R E M A R K S

This Amendment is responsive to the Office Action mailed March 3, 1995, in which claims 1-40 were rejected. With this response, claims 1, 2, 4, 6, 8, 13, 16, 18, 25, 26, 28, 29, 33 and 34 have been amended, and claim 41 has been added. Claims 1-41 remain in the application and are presented for consideration and allowance.

Fig. 1

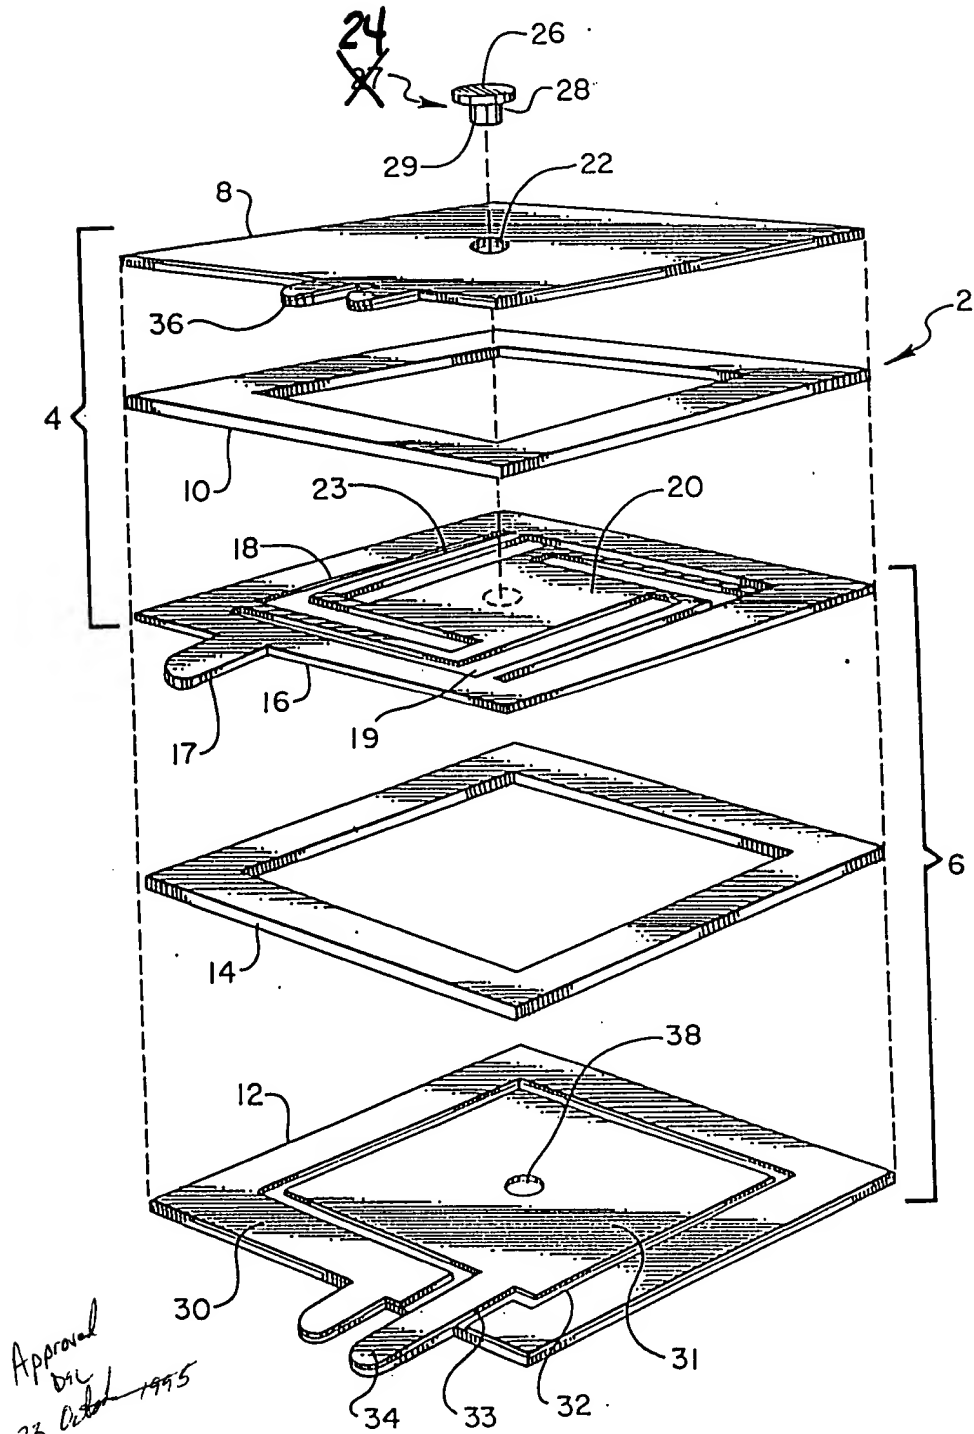
The Examiner objected to the drawings because they do not include certain reference signs mentioned in the description. Specifically, the Examiner stated:

The following reference lines are not included in the drawing:

Numeral 24, the "force transmitting means/sample holder",
Page 23, line 6, 8, 11, 22, and 25,
Page 24, lines 2 and 6,
Page 25, lines 1 and 8, and
Page 28, line 7. Correction is required".

The Examiner objected to the specification stating that it did not include certain reference signs shown in the drawings. Specifically, the Examiner stated, "the following reference signs are not mentioned in the description: Numeral '27', figure 1. Correction is required."

In response, Applicant has changed drawing Fig. 1, element 27 (which was mislabeled), to element 24. With this correction, Applicant believes the above objection to the drawings has been

As previously described, Applicant has changed numeral "27" (which was mislabeled) in Fig. 1 to numeral 24. With this correction, Applicant believes that the Examiner's above objection to the specification under 37 C.F.R. §1.84(f) has been overcome and
